ADDENDUM NO. 1

CRANDALL ISD – PERFORMING ARTS CENTER ADDITION TO CRANDALL HIGH SCHOOL

AUGUST 26, 2024

A2.15

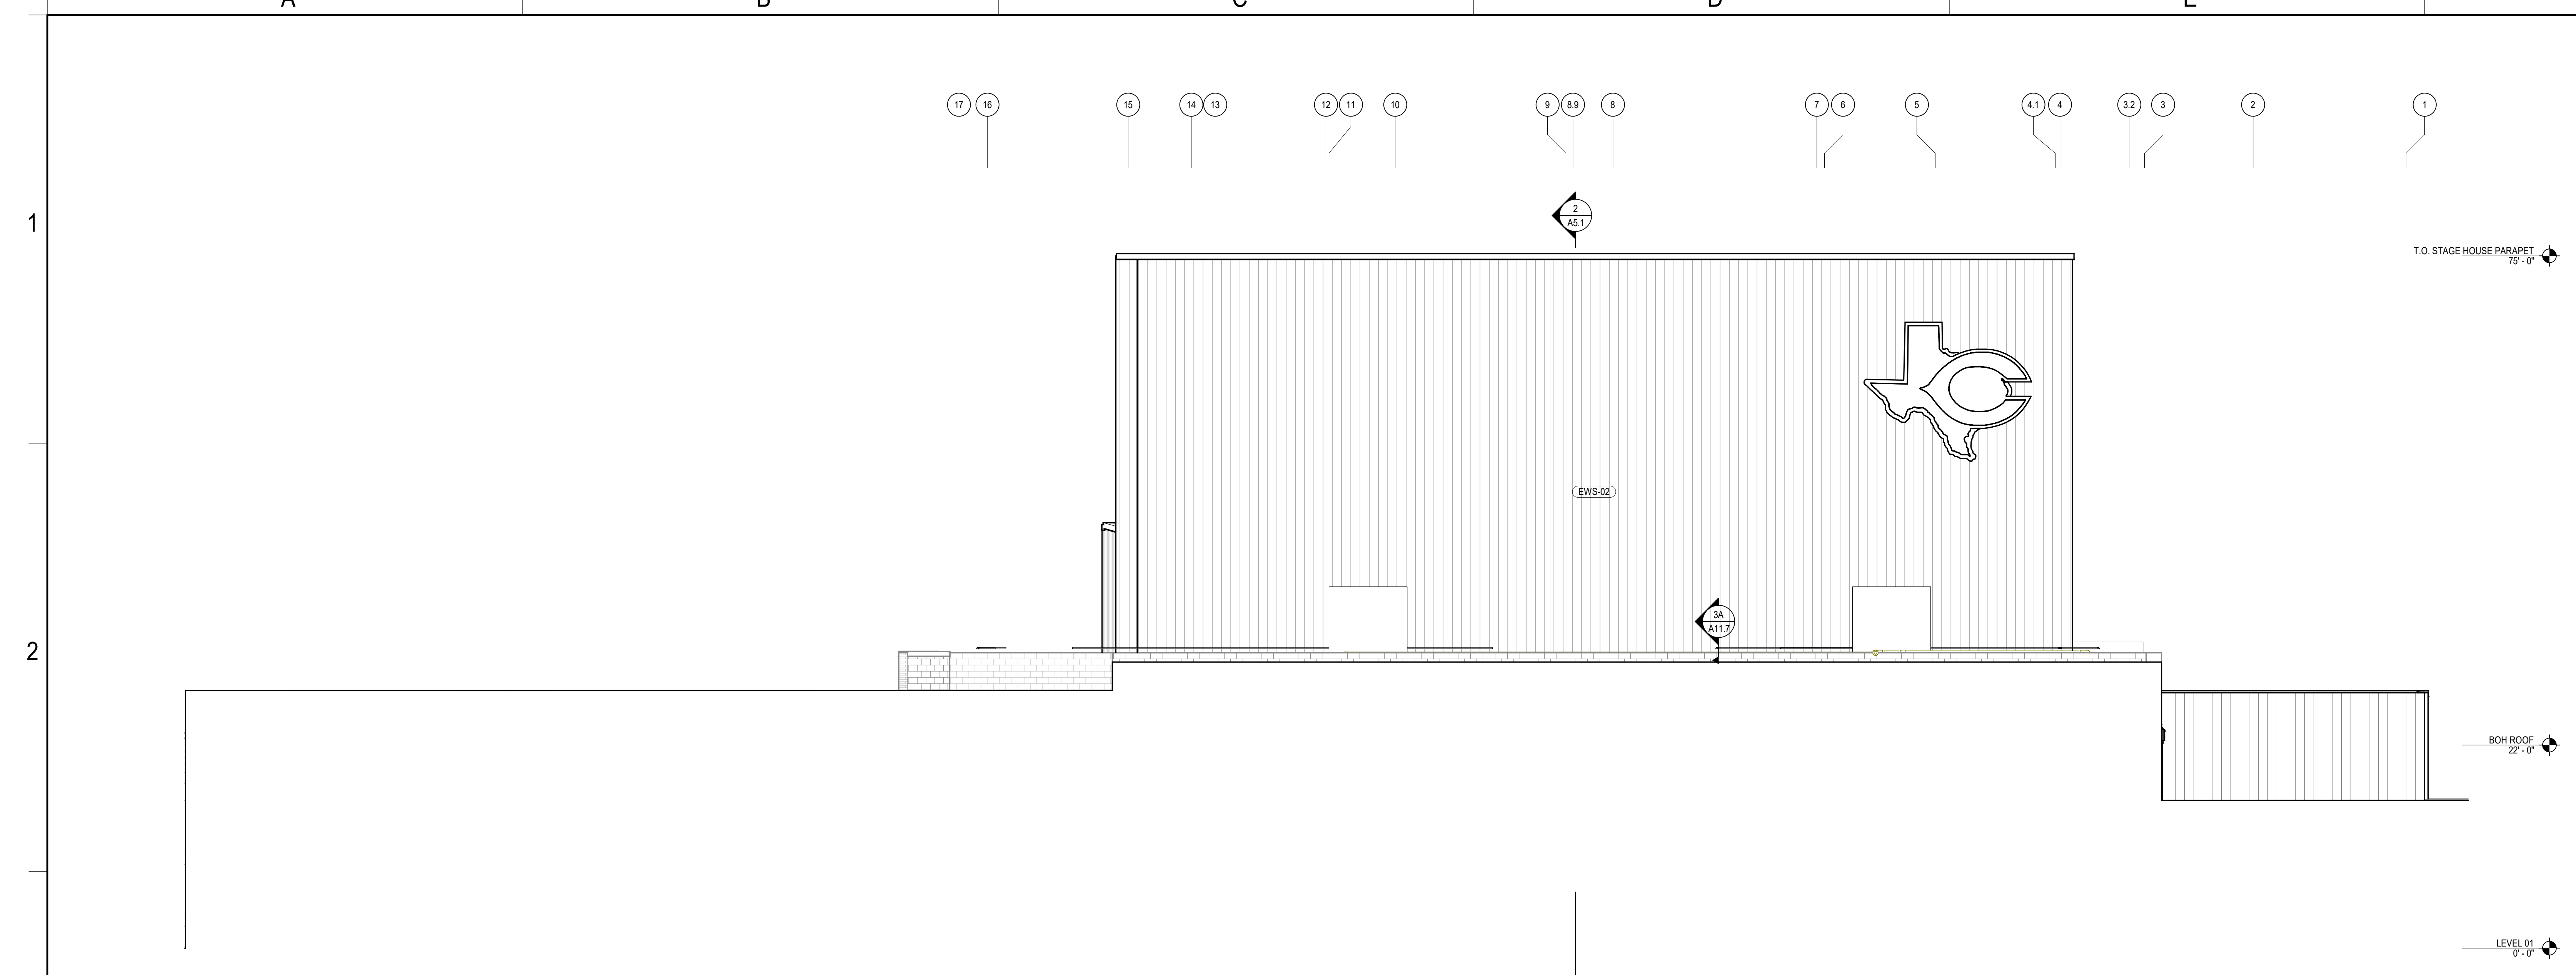
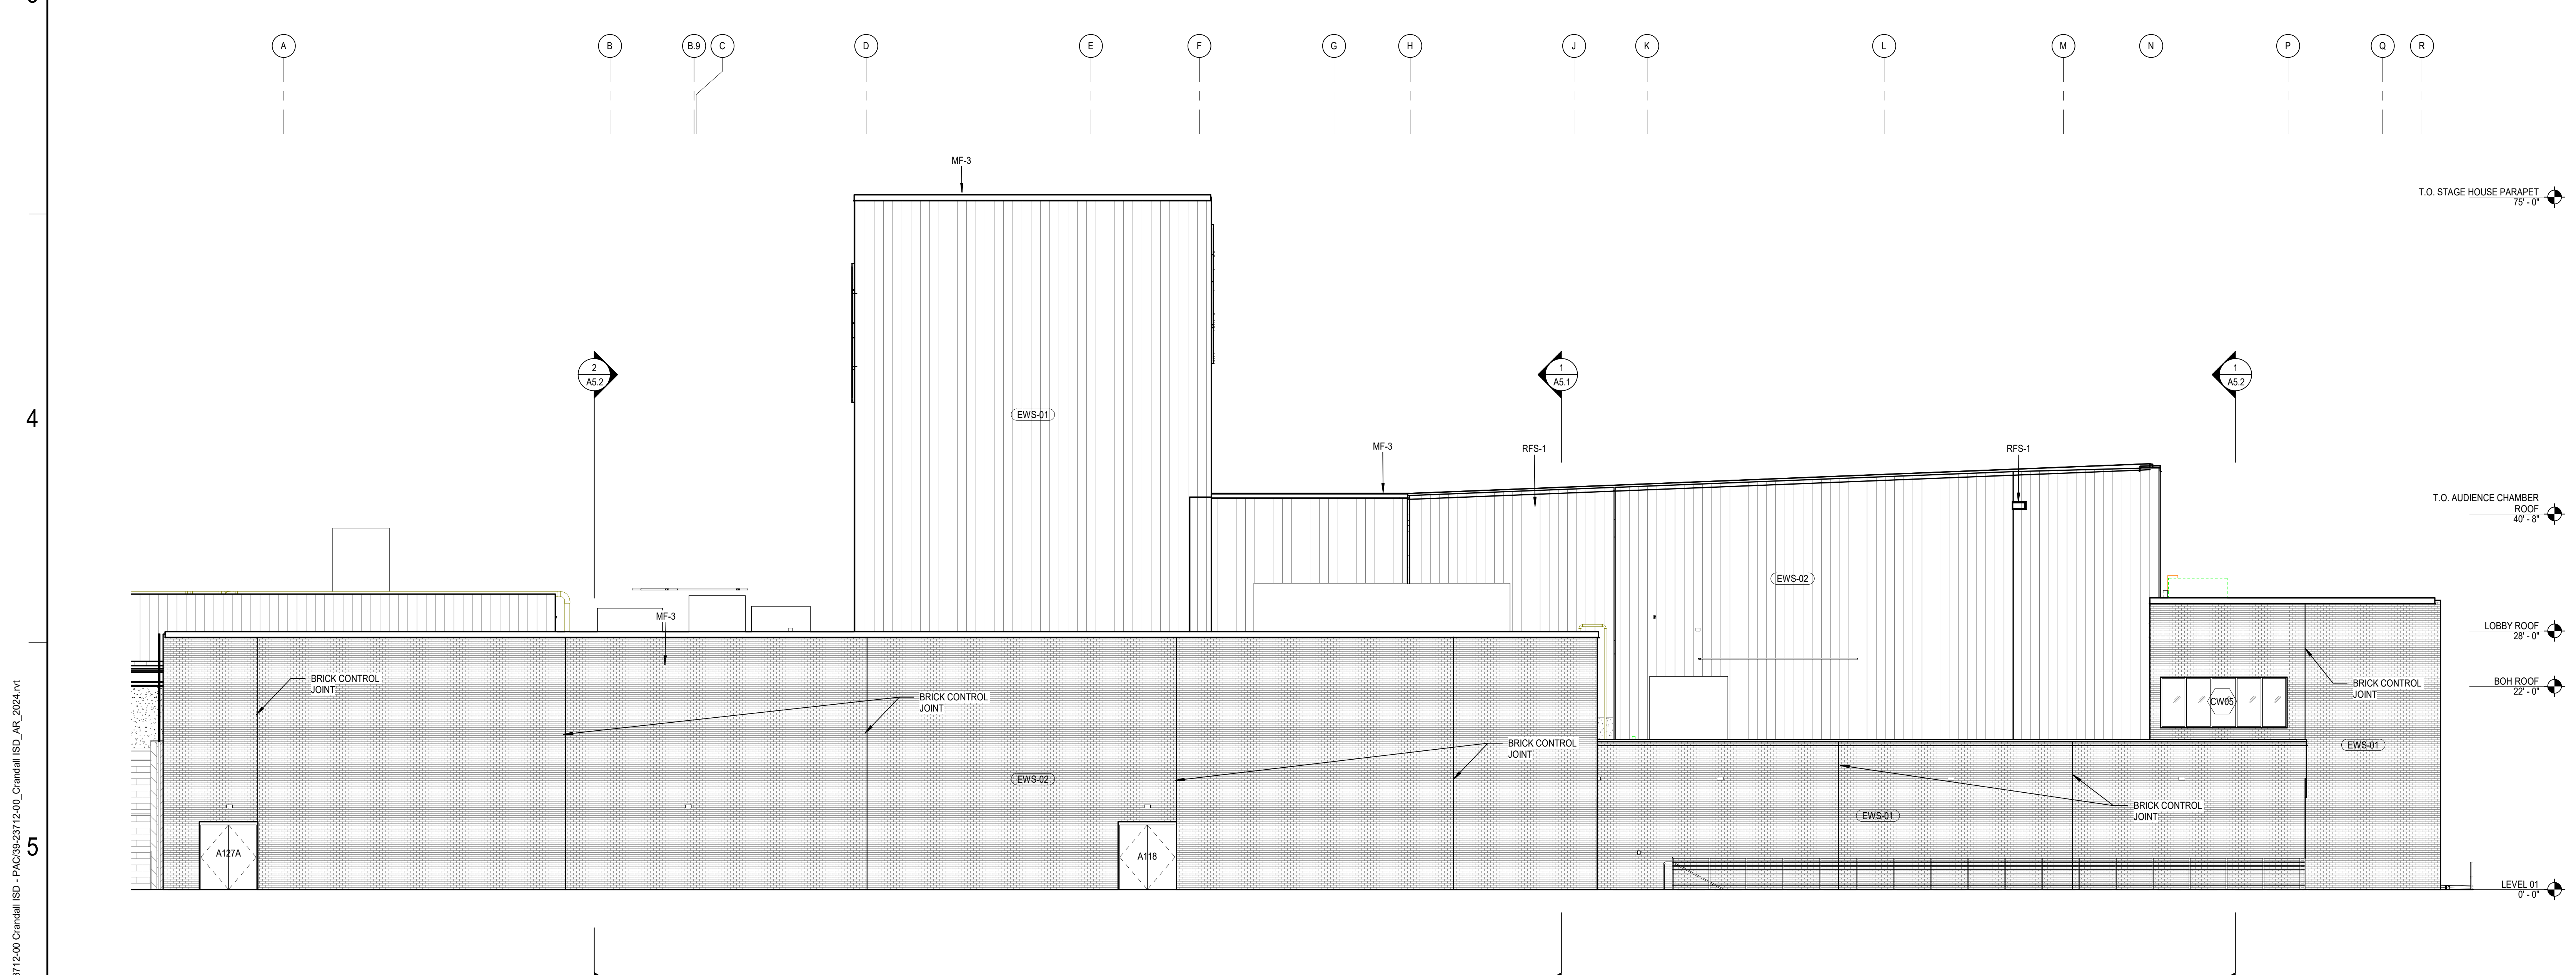
- ITEM 24. A2.15 – ENLARGED RESTROOM PLANS AND ELEVATIONS – FRONT OF HOUSE – Mirrors in group restroom walls have been changed in size as indicated on the re-issued sheet.

3A NORTH BUILDING ELEVATION
 A4.1 SCALE: 1/8" = 1'-0"

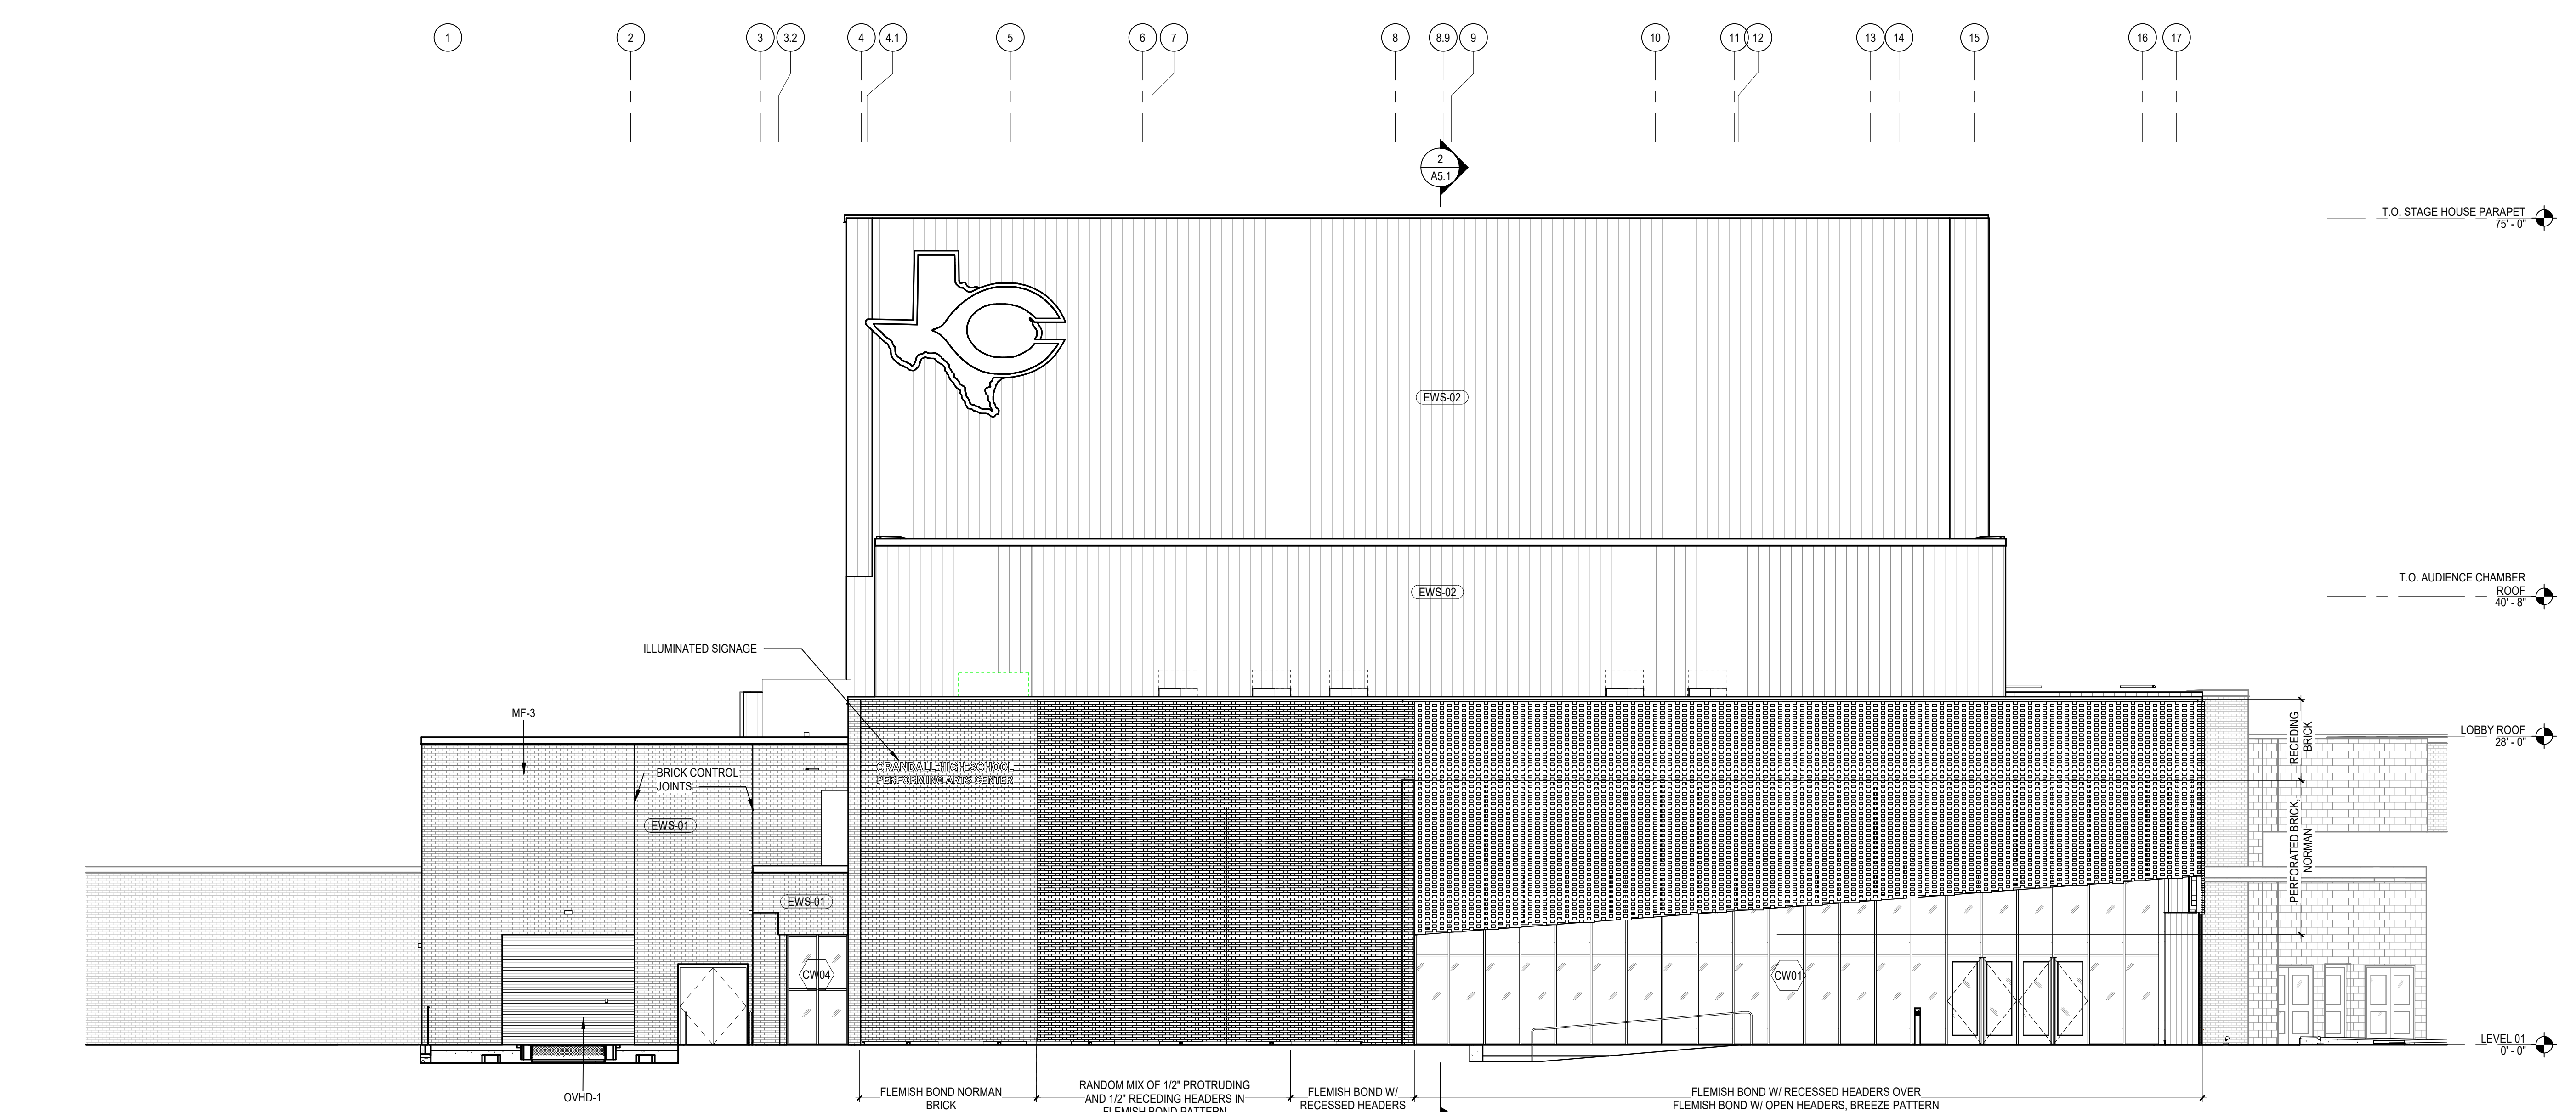
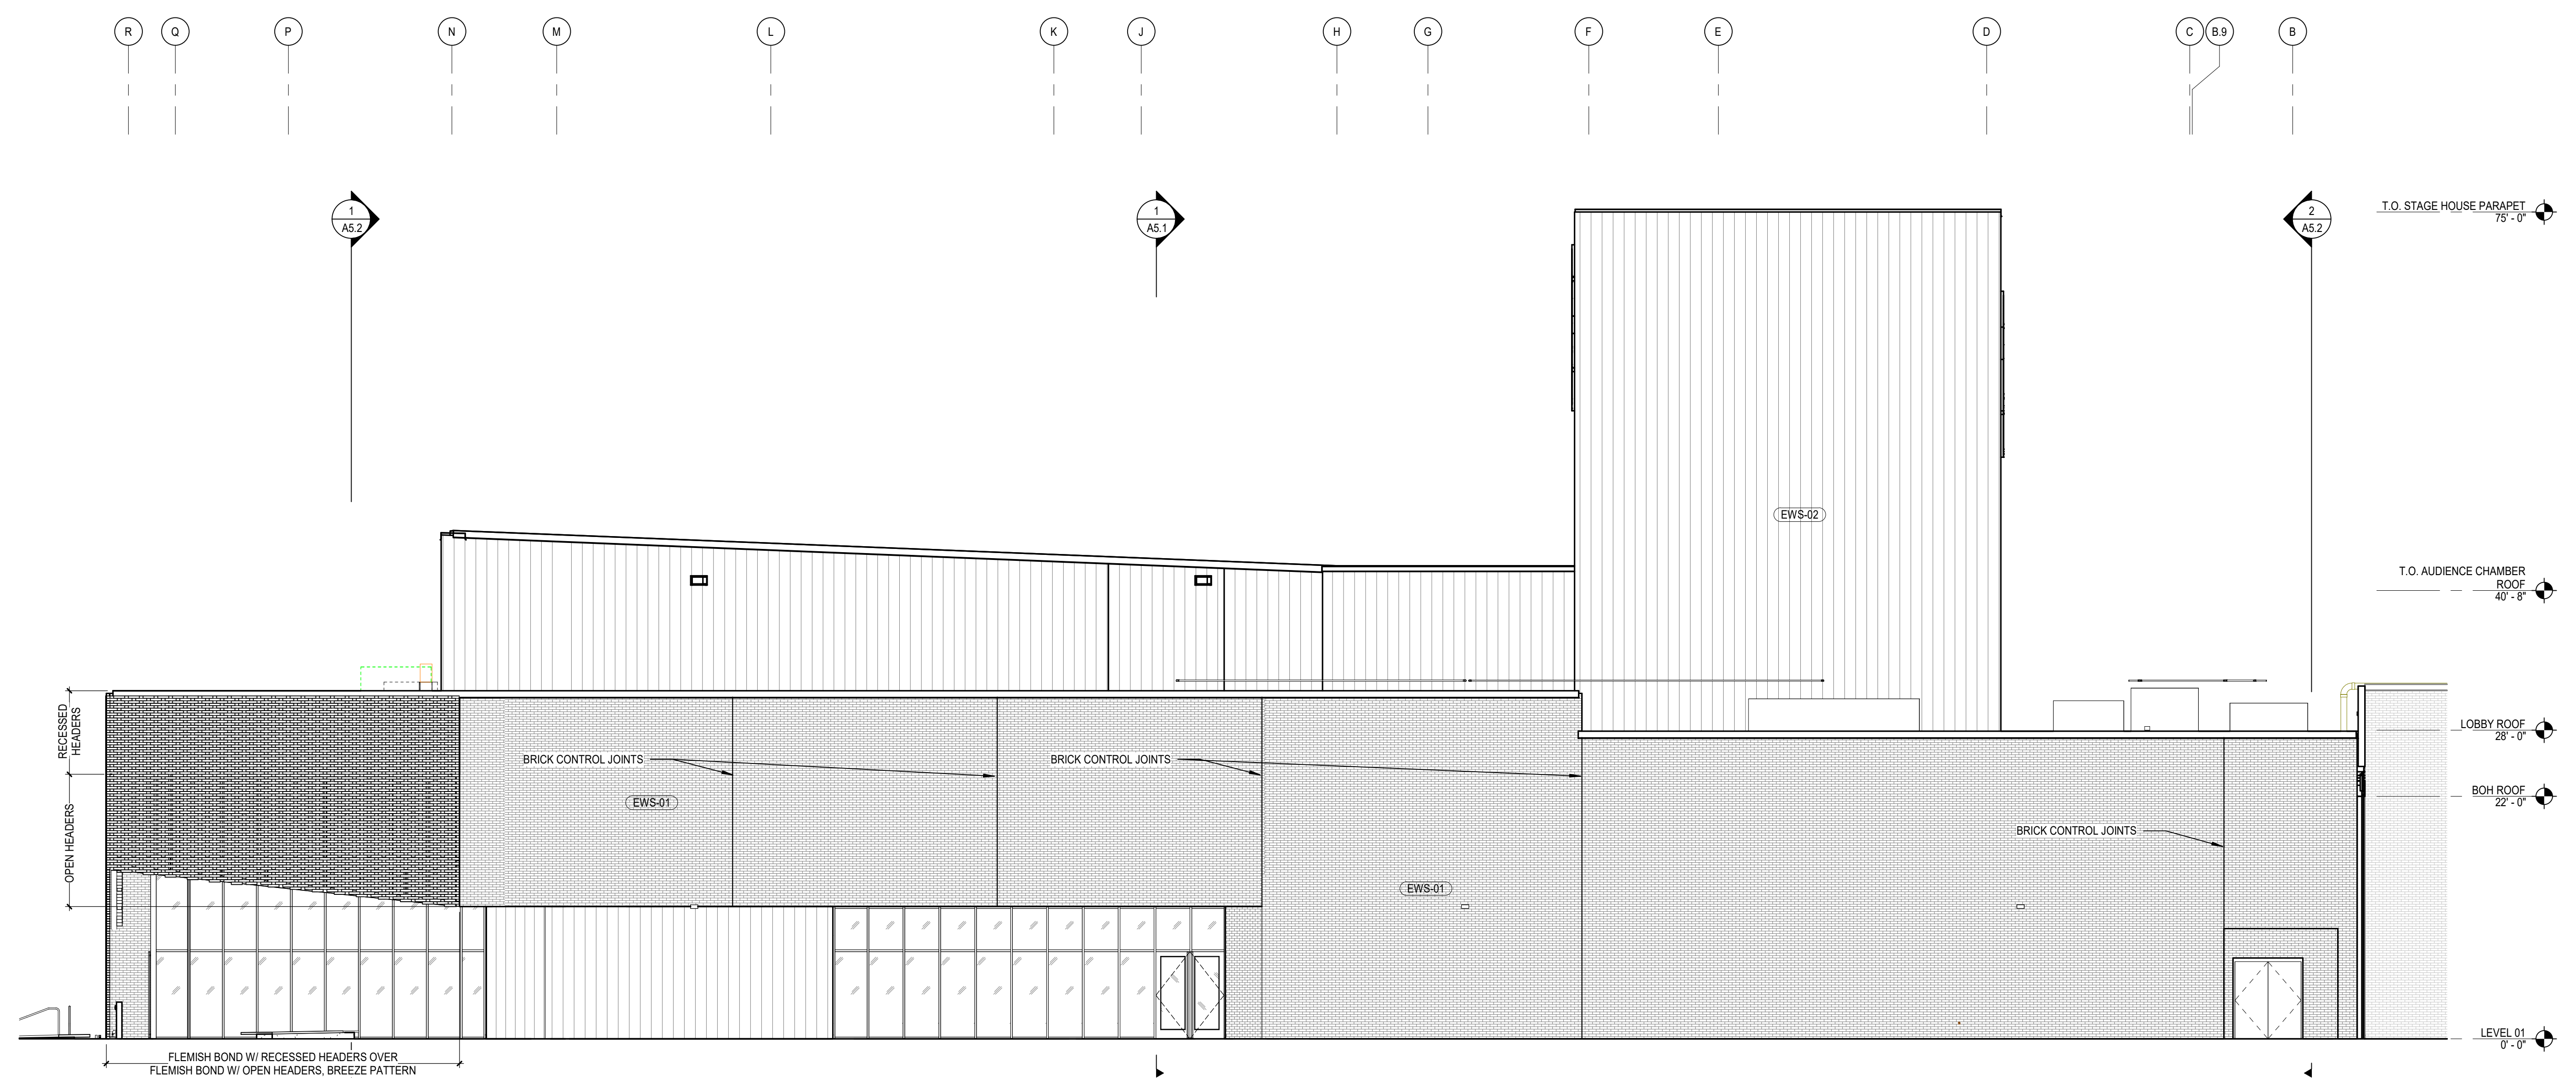
- ITEM 25. A4.1 - EXTERIOR ELEVATIONS – Brick control joints have been added as indicated on the re-issued sheet.
- ITEM 26. A4.2 EXTERIOR ELEVATIONS – Brick control joints have been added as indicated on the re-issued sheet.
